MODEL: SA-1040

SUBJECT: Addition of Diodes to AF ASS'Y (GWK-228).

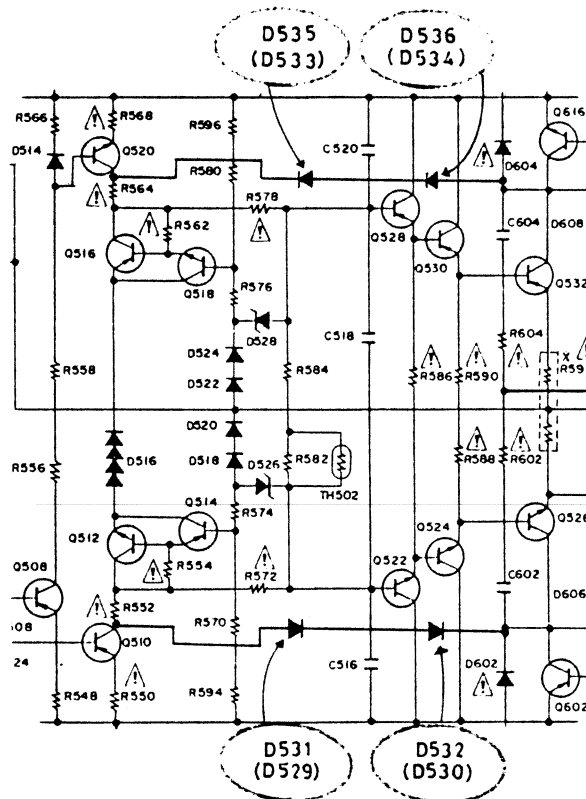
REASON: To protect power transistors.

- R ----- D531, D532, D535, D536 : (Added) —————> 1S2471
- L ----- D529, D530, D533, D534 : (Added) —————> 1S2471
